Land at Bird in Eye Farm
South of Bird in Eye Hill
Uckfield

TRANSPORT ASSESSMENT SECOND ADDENDUM

Planning Reference: WD/2021/2198/MAO

MT/5330/TA2A.2
September 2022

DRAWN BY ARM	DESIGN BY MT	CHK BY MT
DATE 30/04/20	DRAWING No. 5330 / 008	
SCALE 1:1,000 @ A2	REV No. H

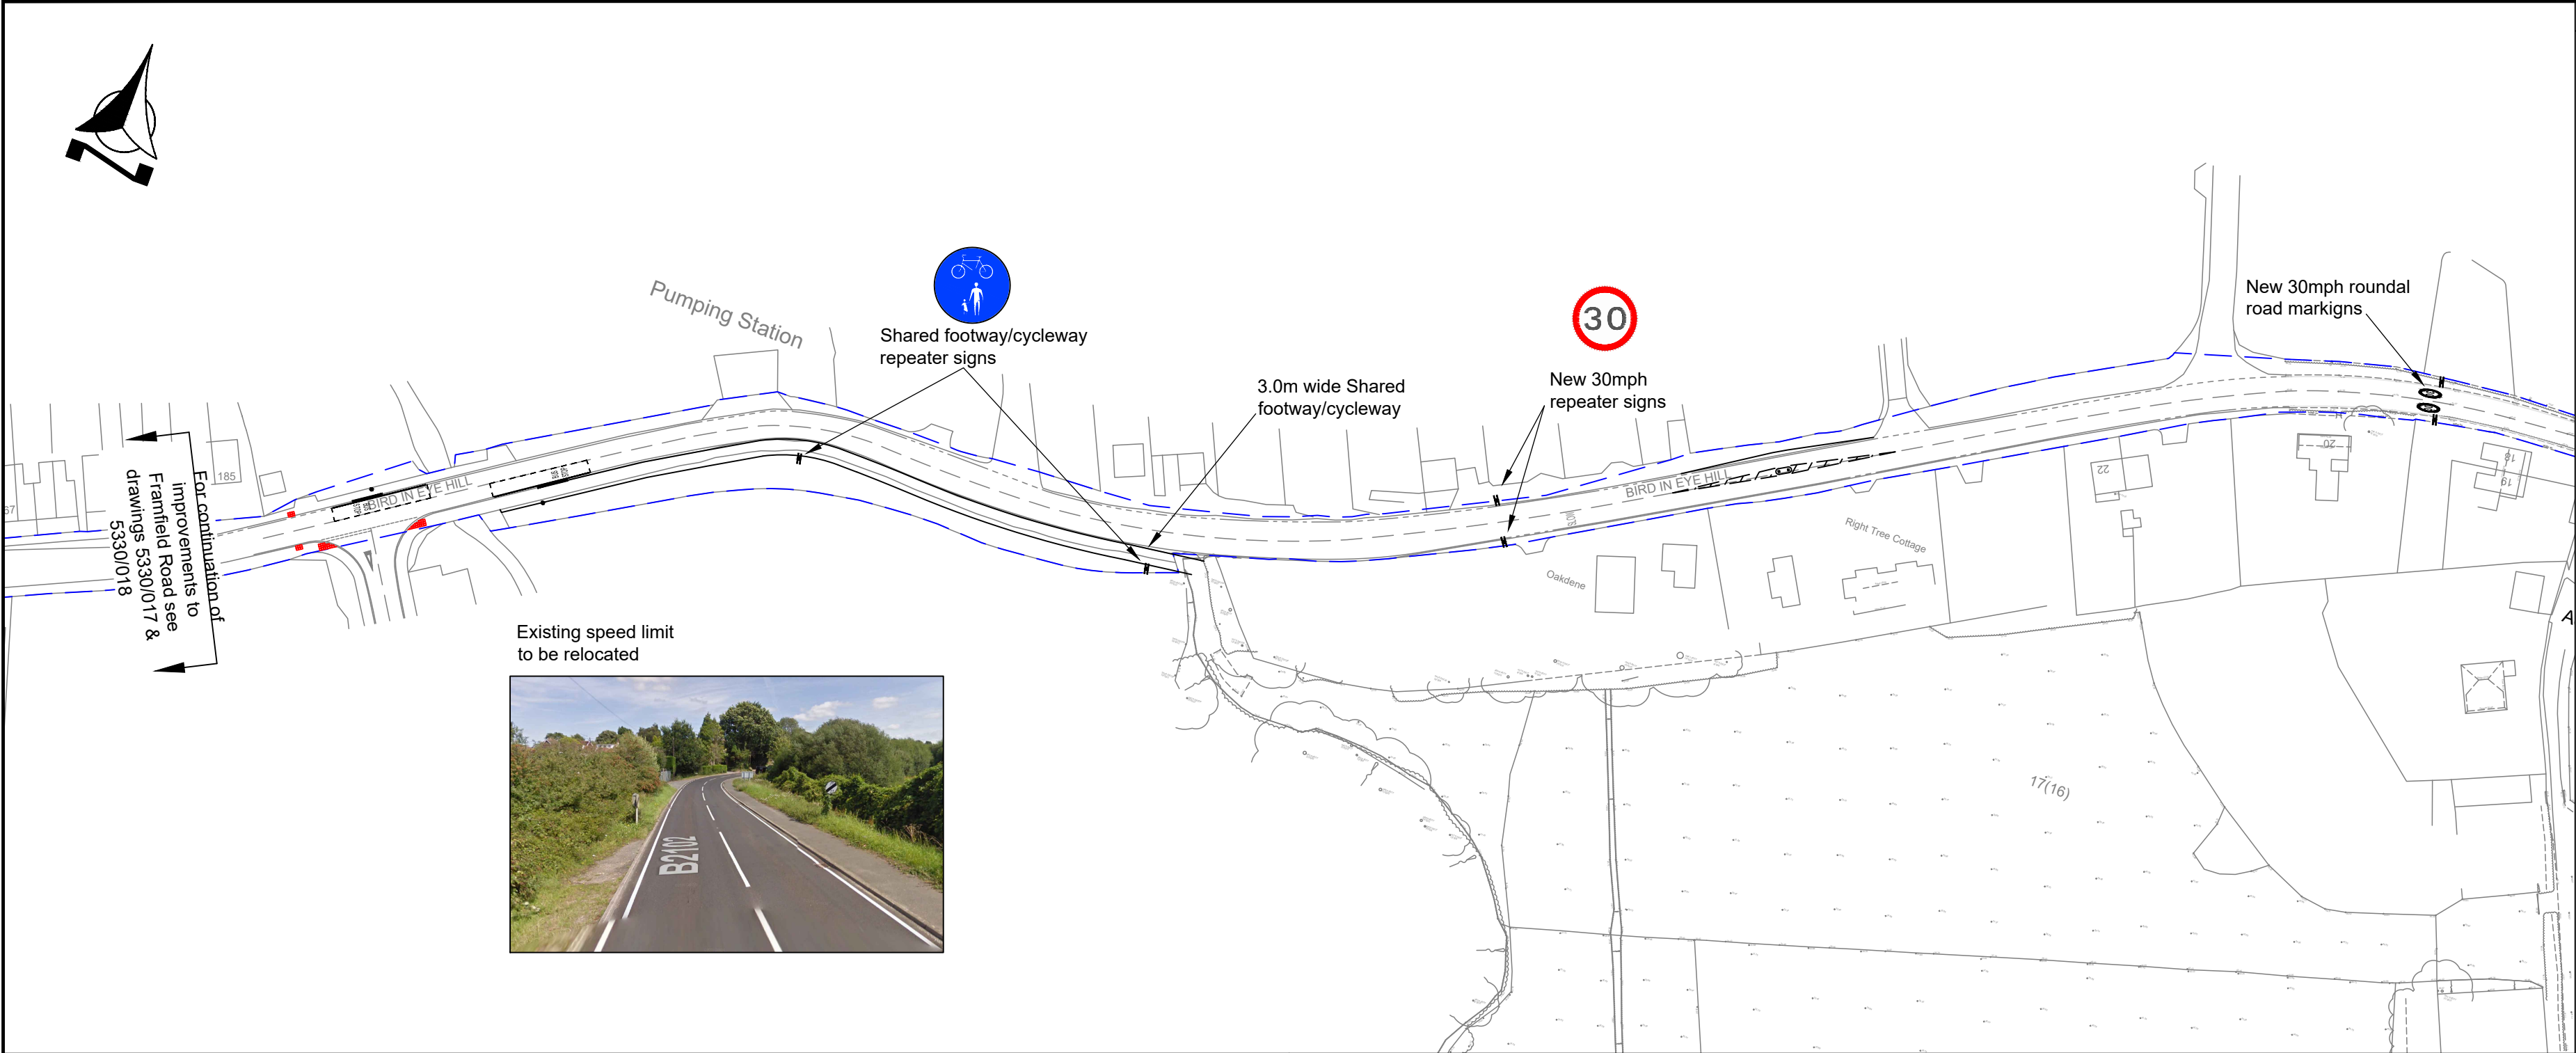
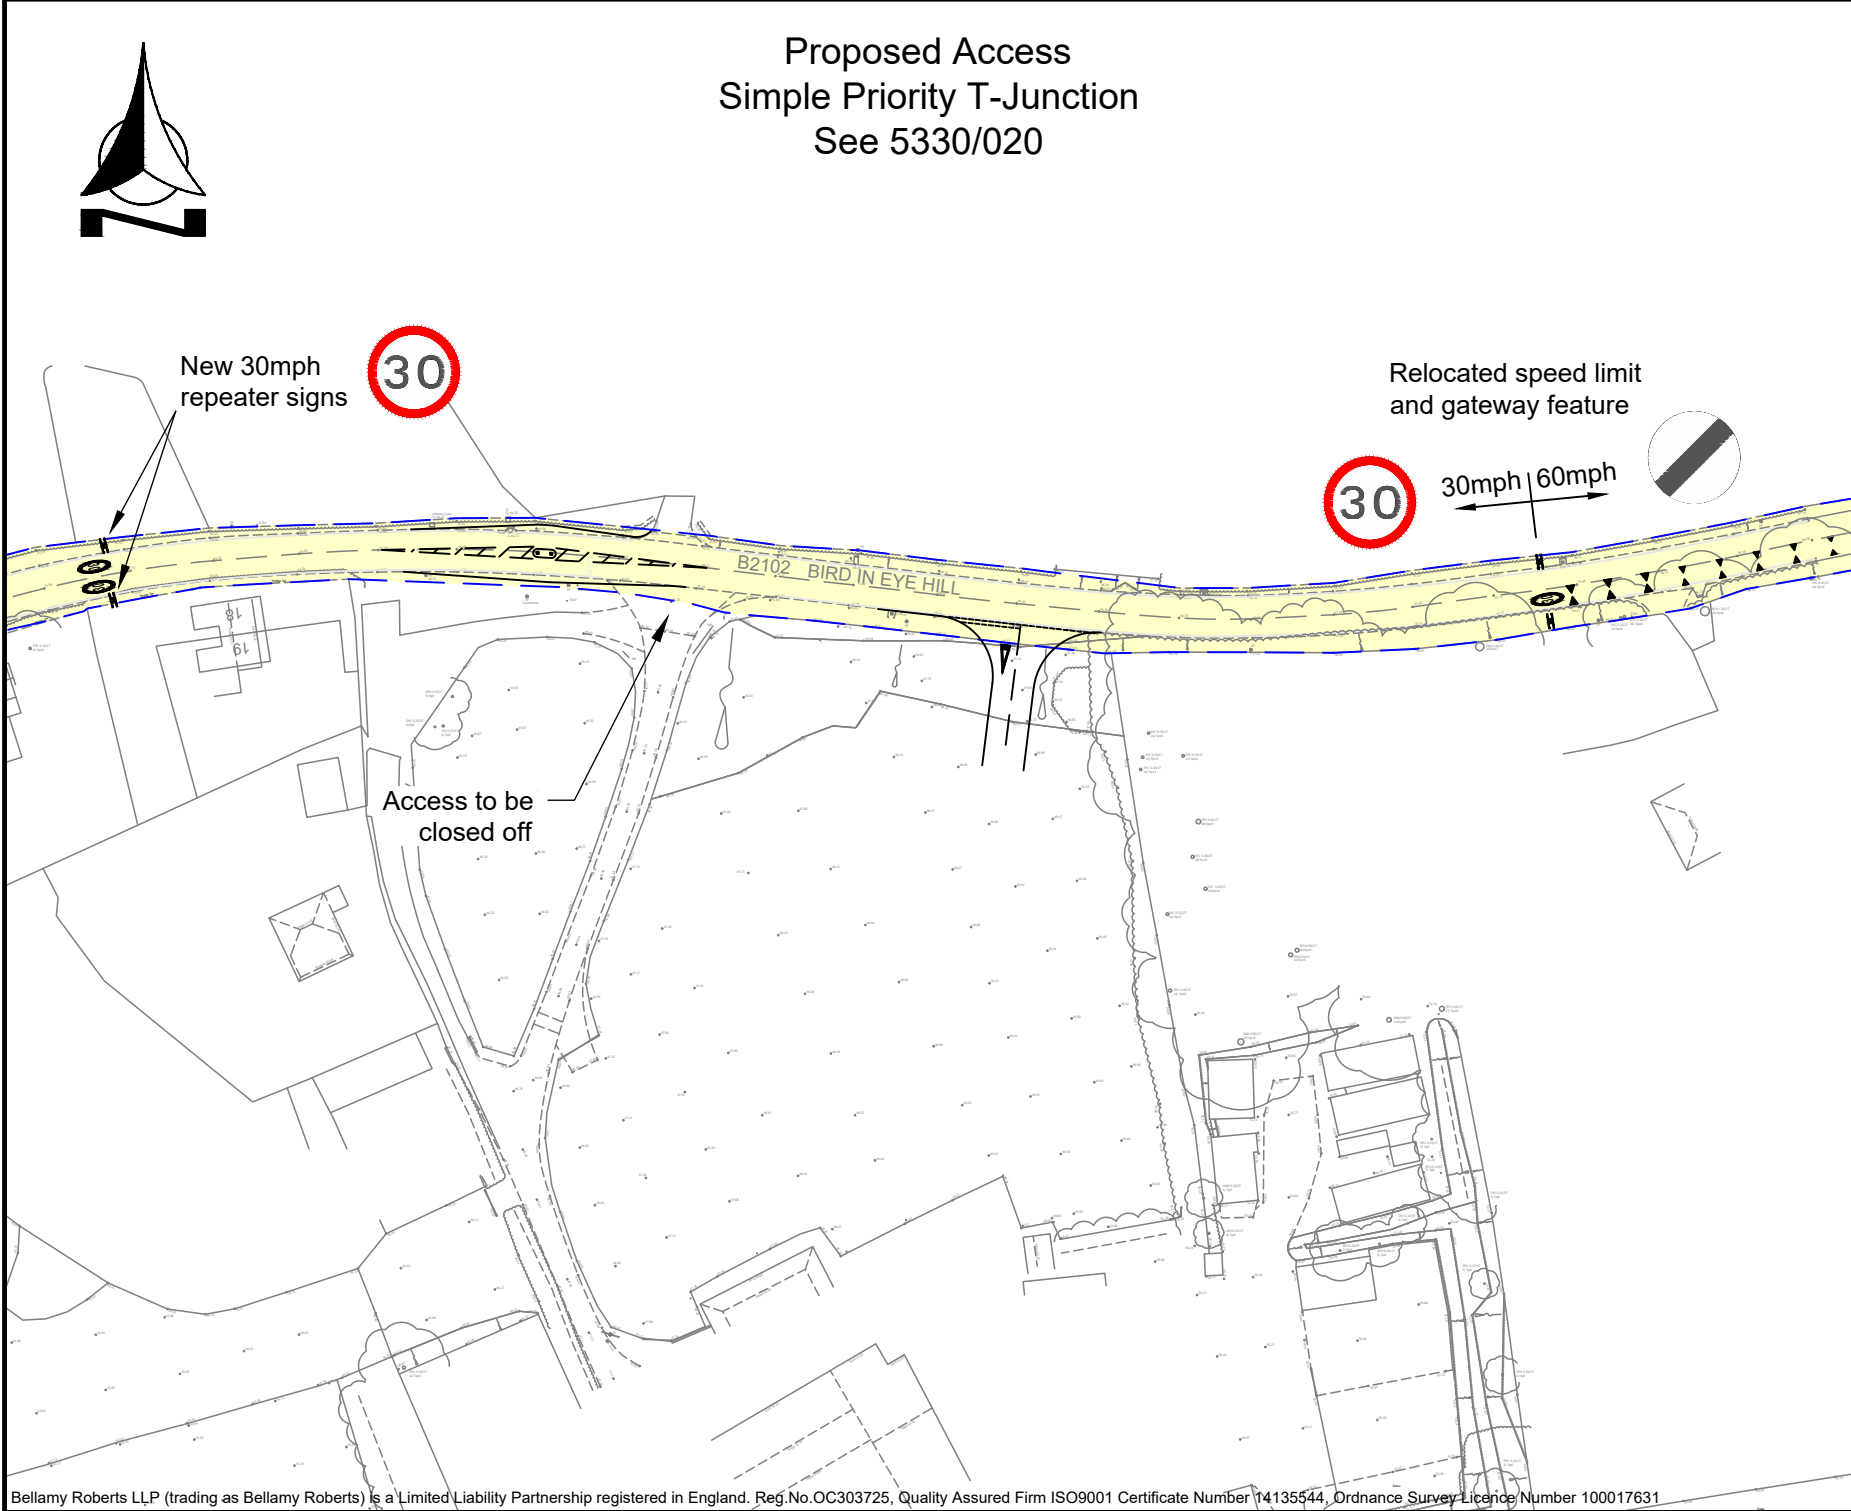
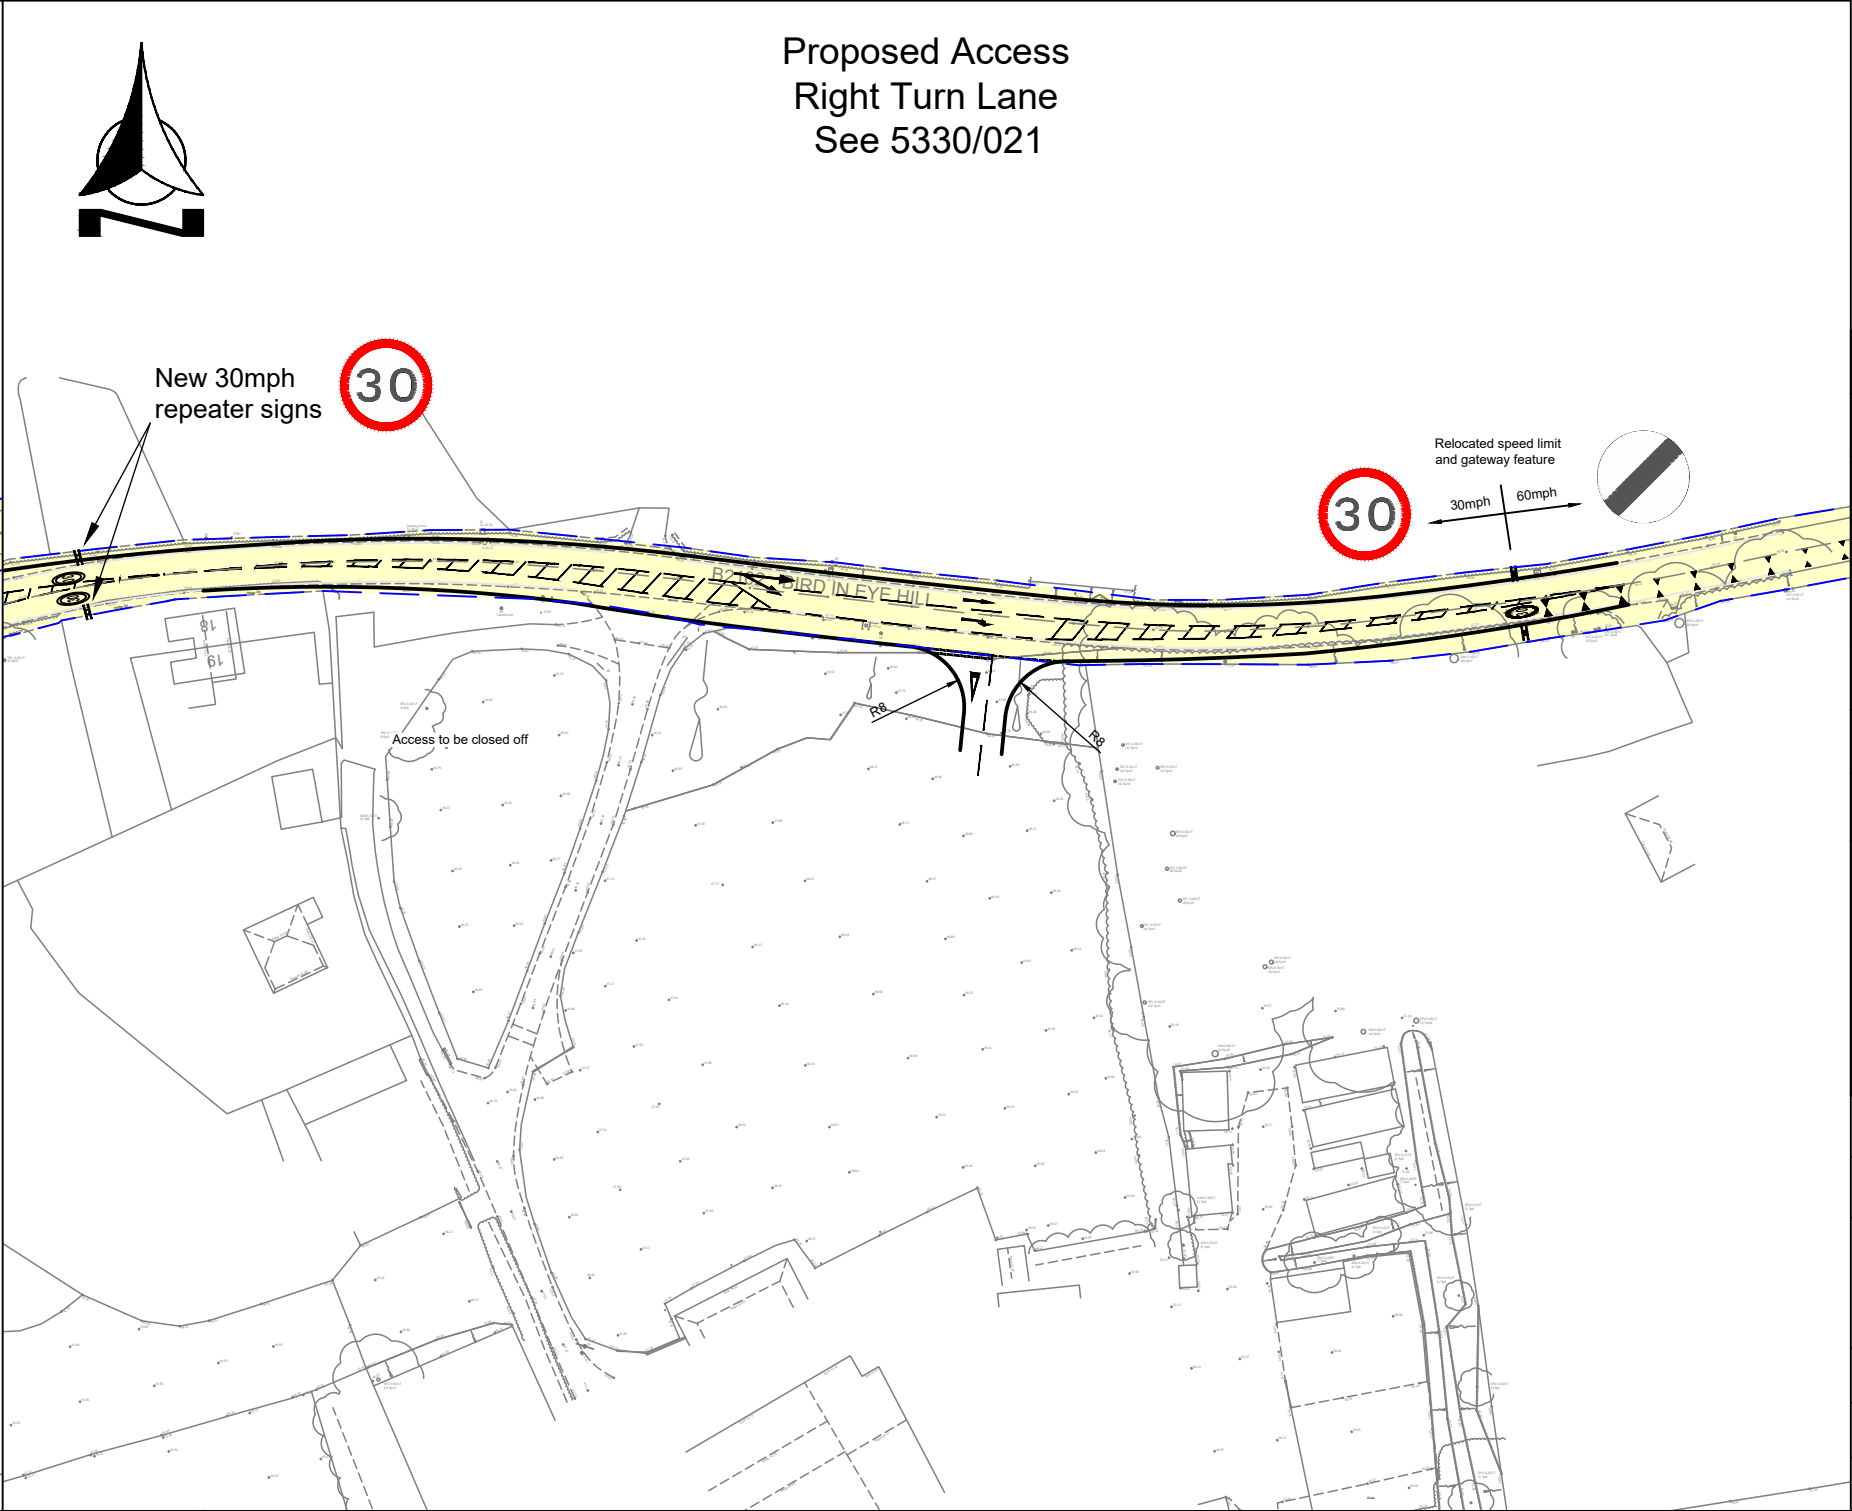
Splitter islands on Bird in Eye Hill: the proposed tapers are not in accordance with CD123, and revisions have been made in dwgs 5330/008E, 020C and 016E. I do not have access to these drawings as they are not provided as part of the TA addendum or application submission.

2.41 Drawings 5330/008 (**Appendix 8**) and 016 (**Appendix 9**) have been amended following comments received from the Safety Auditor and from the CHA, particularly regarding the previously proposed improvements to the bus stops at the Hospital access. The CHA has recently Technically Approved improvements to these bus stops as part of the nearby Mallard Drive development. This drawing has been supplied by the CHA and our proposed improvements have been amended to reflect these works.
